325 - 327 Deansgate – Manchester

Section 73 | December 2025
10185-SHP-A-B5D8-RP-DAS-004 | P01

The following Addendum has been prepared in support of a Section 73 application for 325-327 Deansgate, Manchester.

3.4 - Amended Design - Level 21 Plan

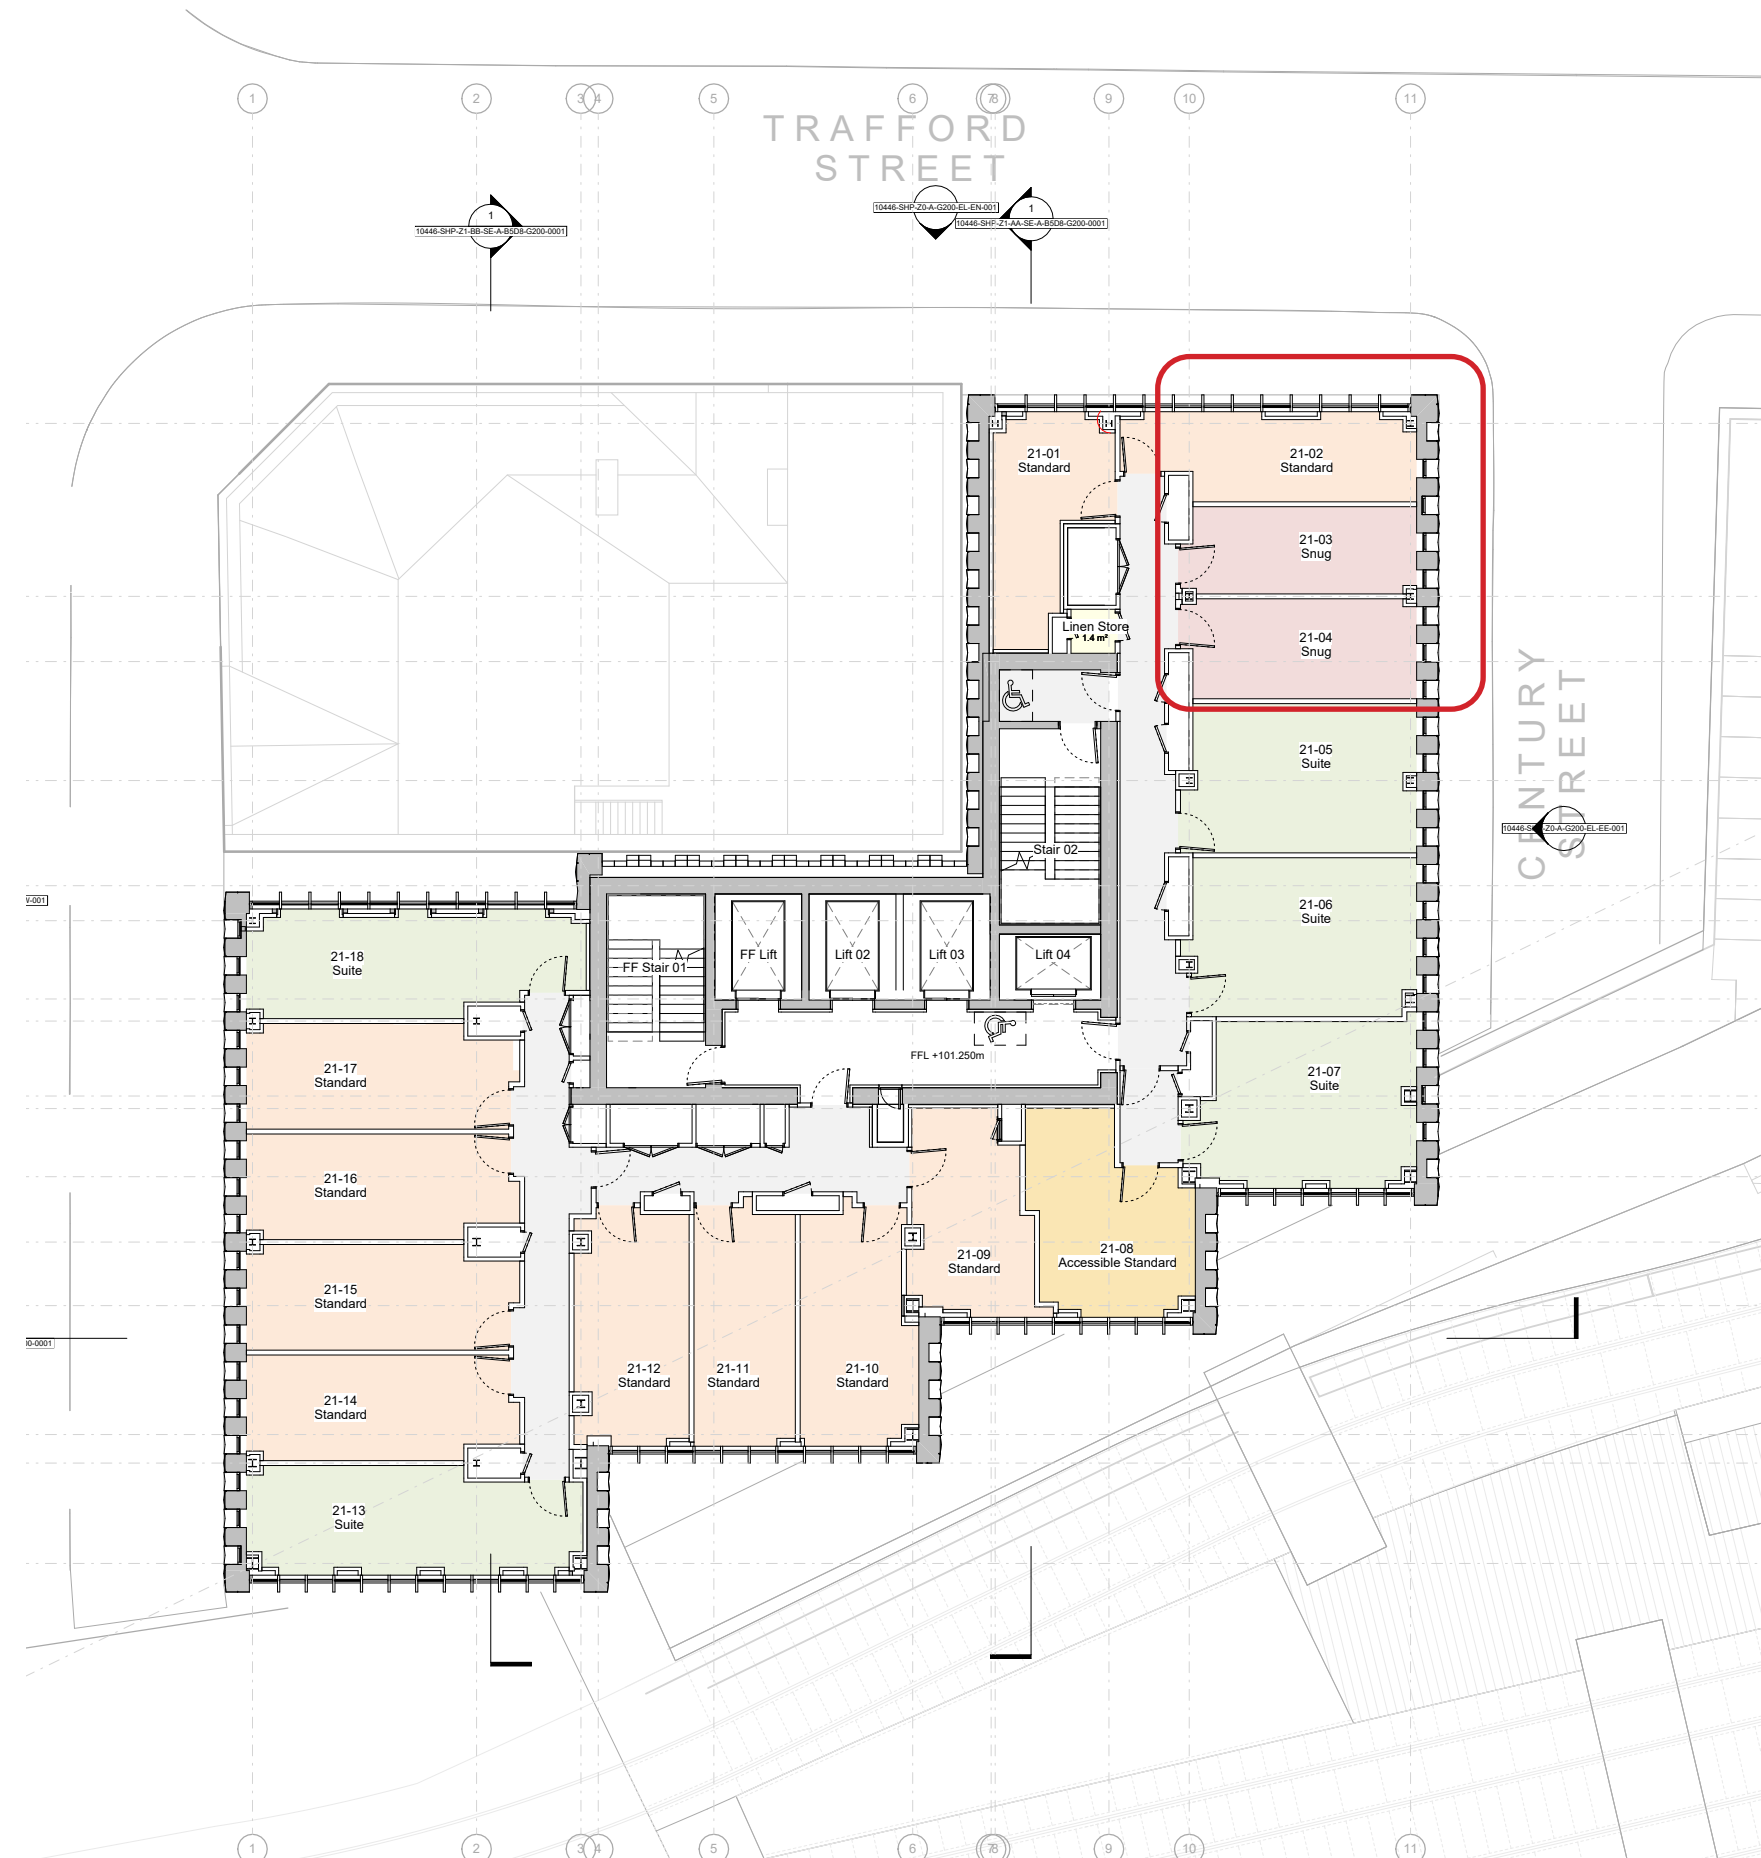
- Minor changes to space planning increasing number of hotel bedrooms from 357 to 358. 2no. suites swapped for 1no. standard room and 2 no. snug rooms.

Proposed Deansgate Elevation Fire Escape

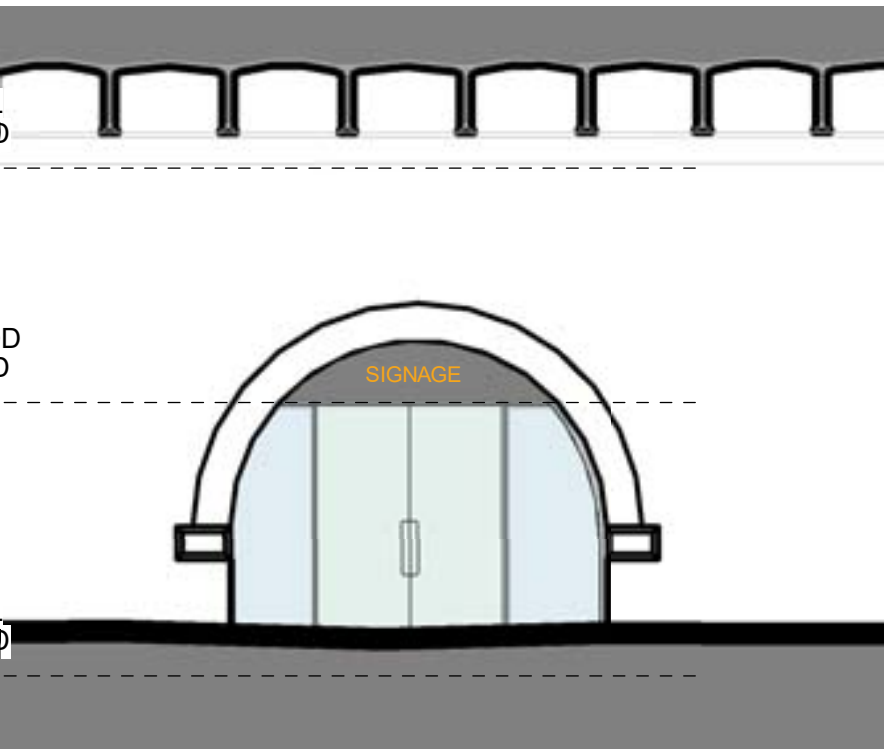
Amendments to Deansgate elevation

- Changes to fire escape glazing. Fully opaque panels proposed to slab edge and fire partition. Clear glazing proposed to the fire escape. The overall extent of fully opaque glazing remains consistent with the 2020 planning approval.

3.6: Amended Design - Century Street Elevation

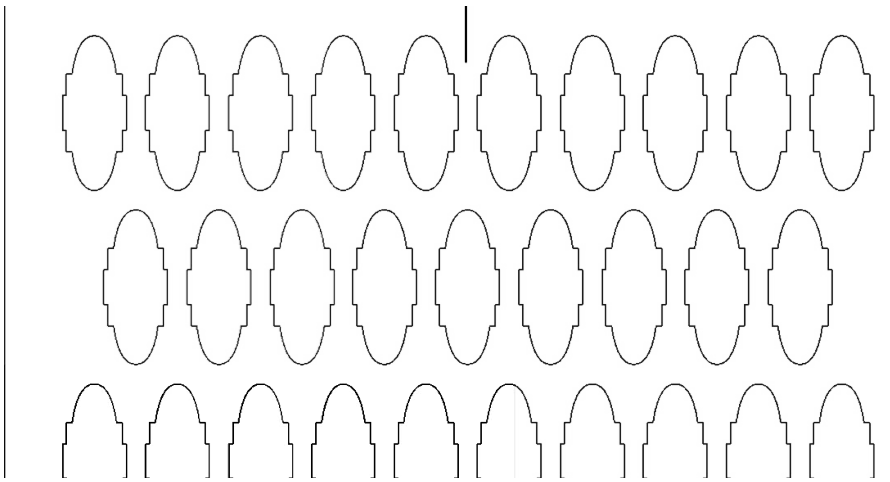
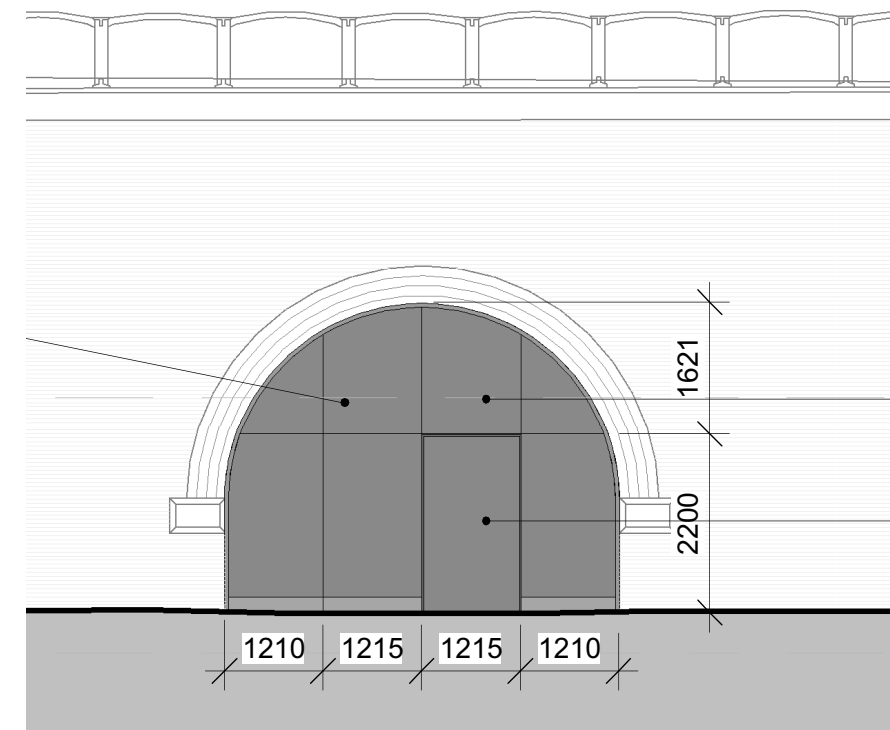
- Level 21 - 1no. clear glazing unit swapped position with 1no. opaque unit
- Linen store door removed
- Decorative panels in 2nd arch opening
- Relocation of louvres at ground and mezzanine levels

3.7 - Amended Design - Whitworth Street Elevation

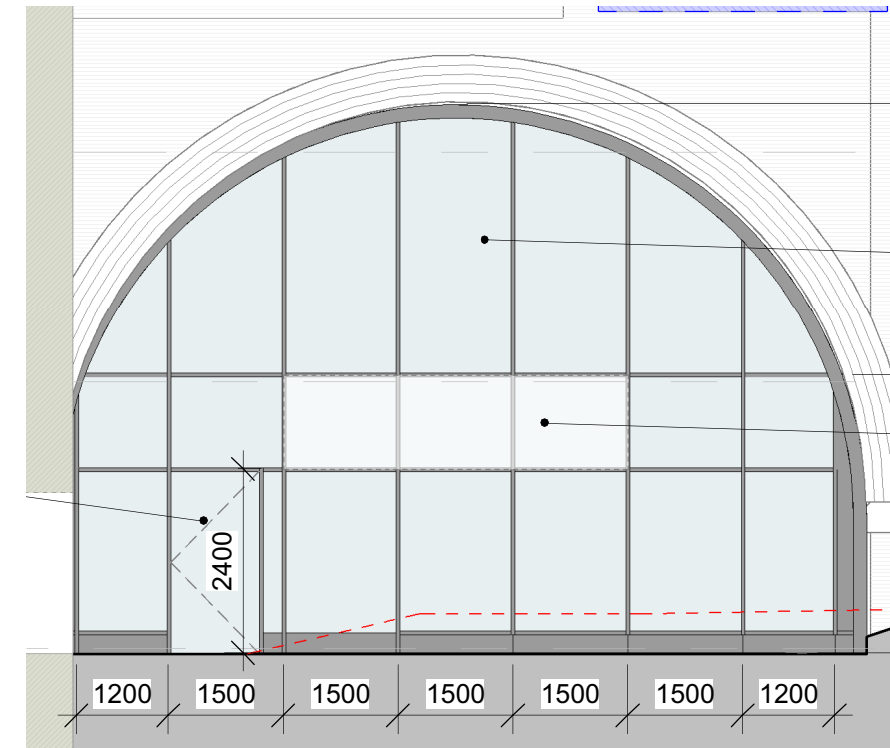
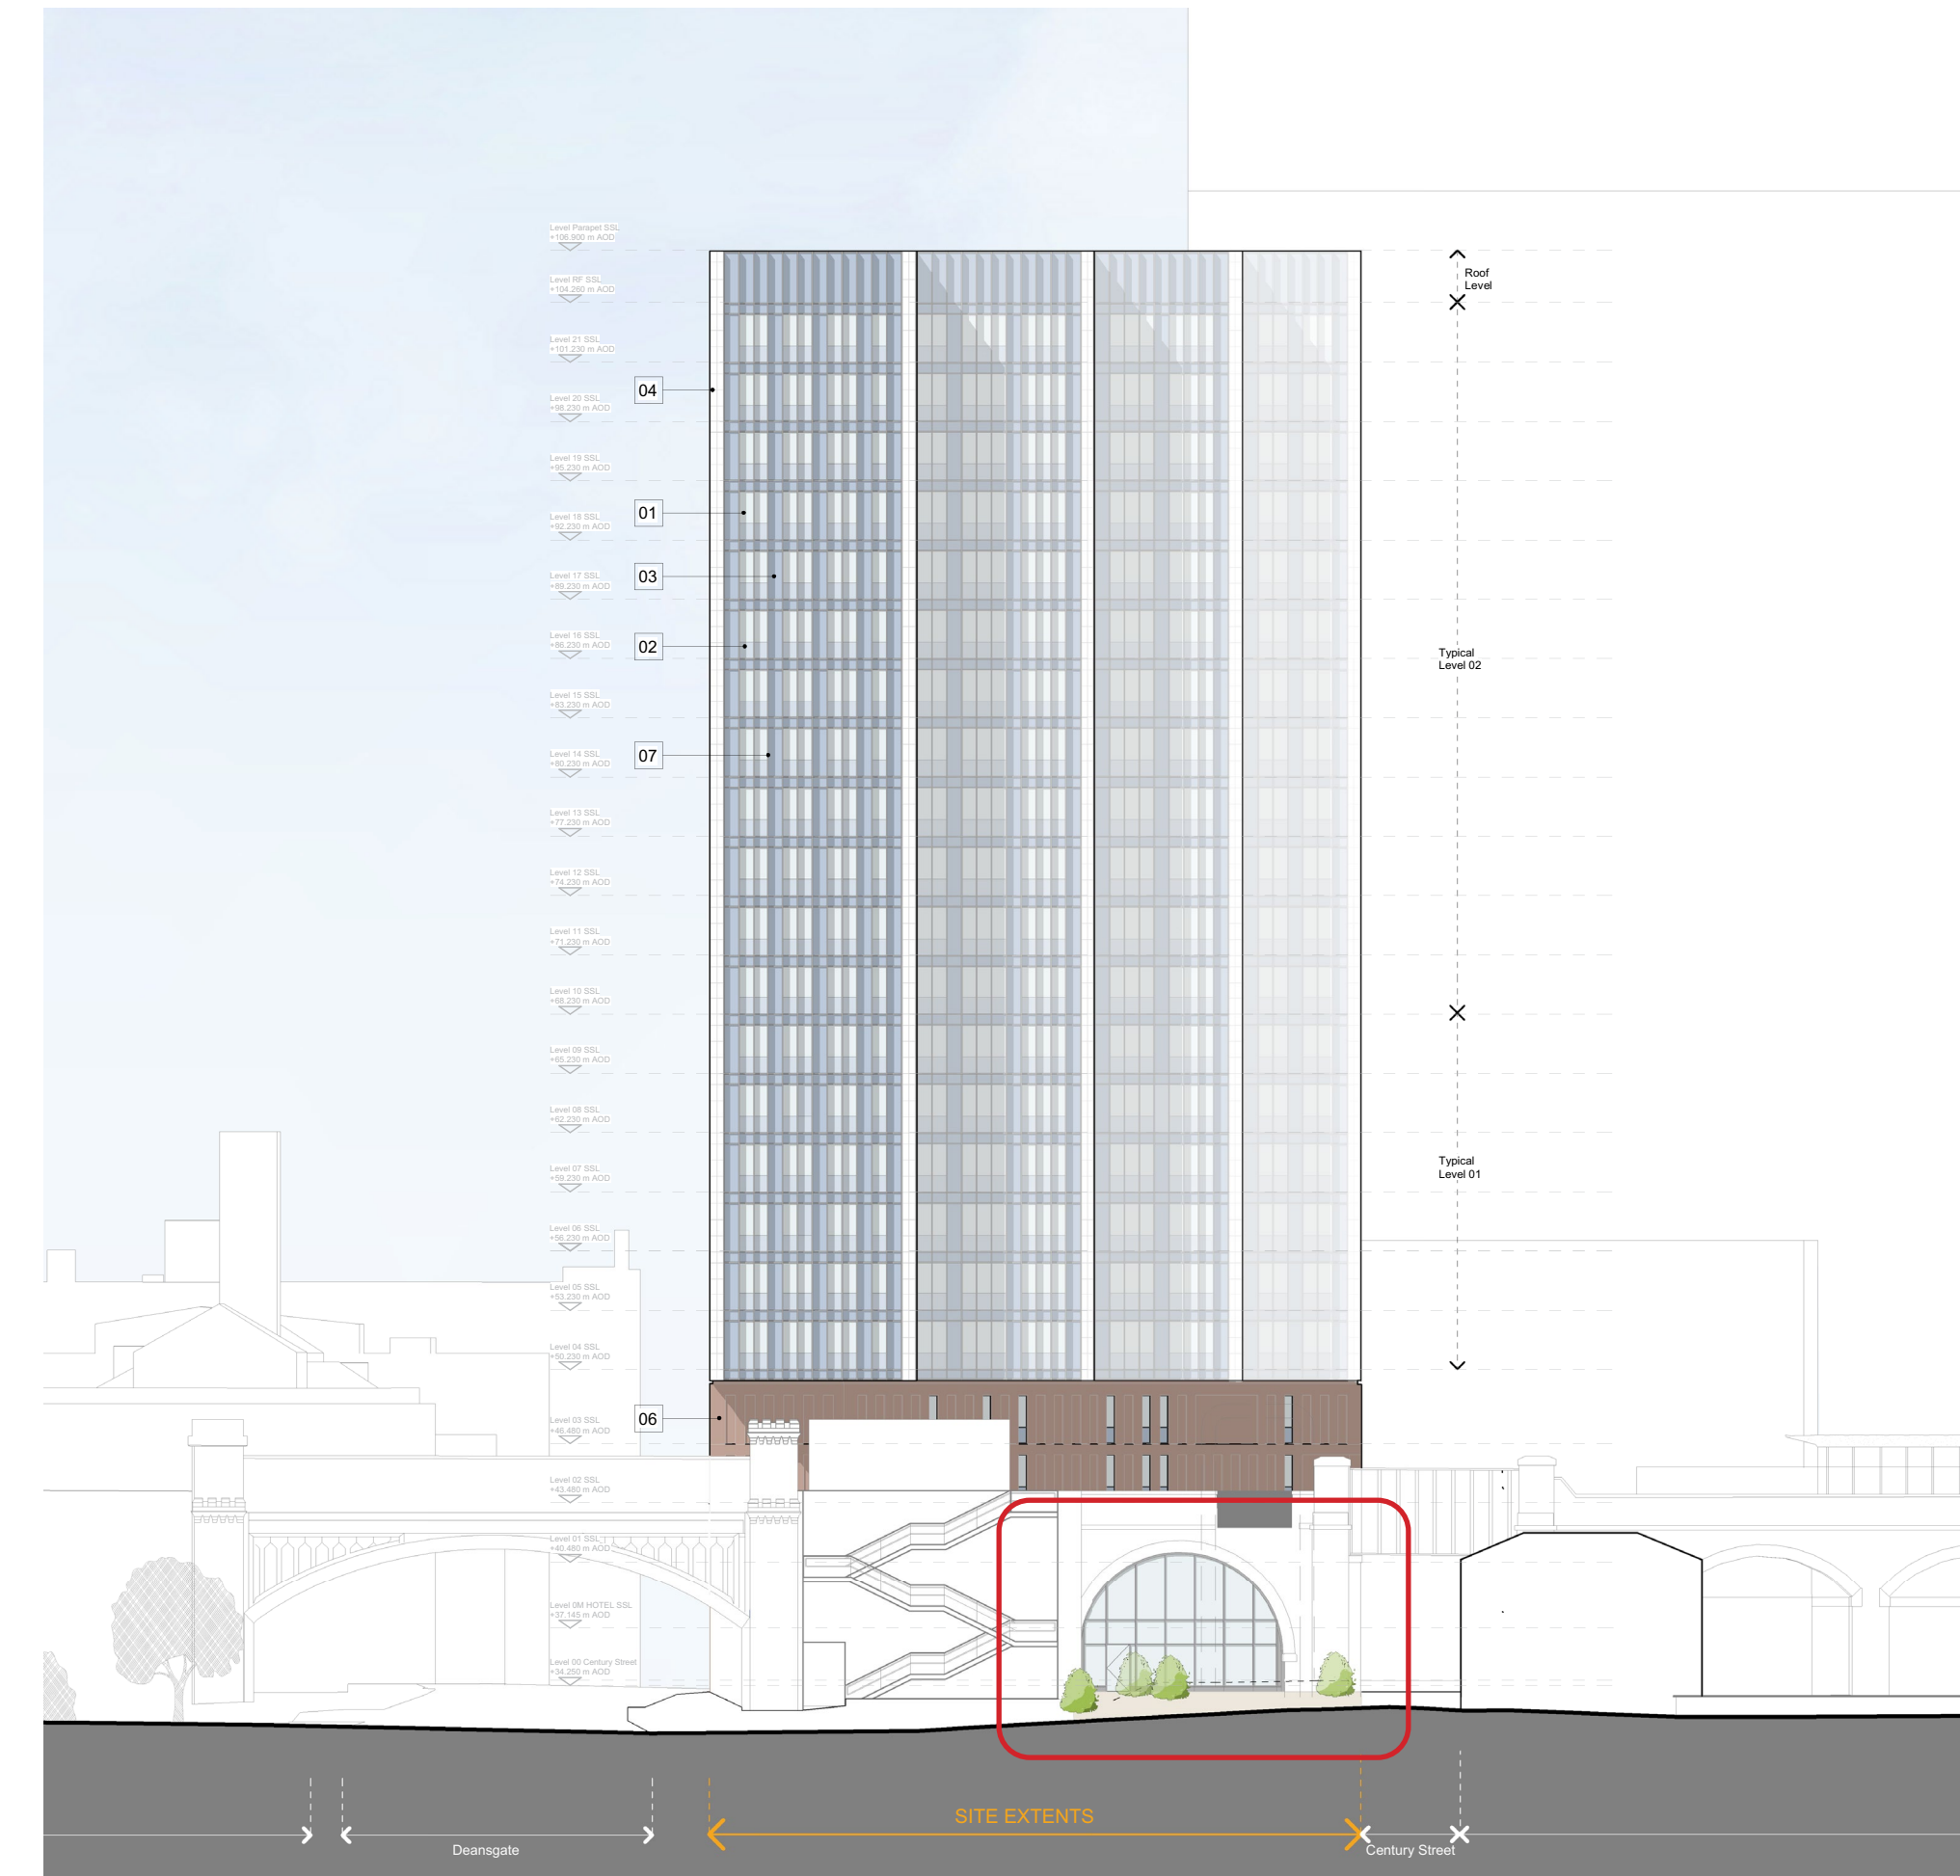
Amendments to Whitworth Street elevation

- Minor changes to 2nd arch curtain walling
- Relocation of 4no.. Trees
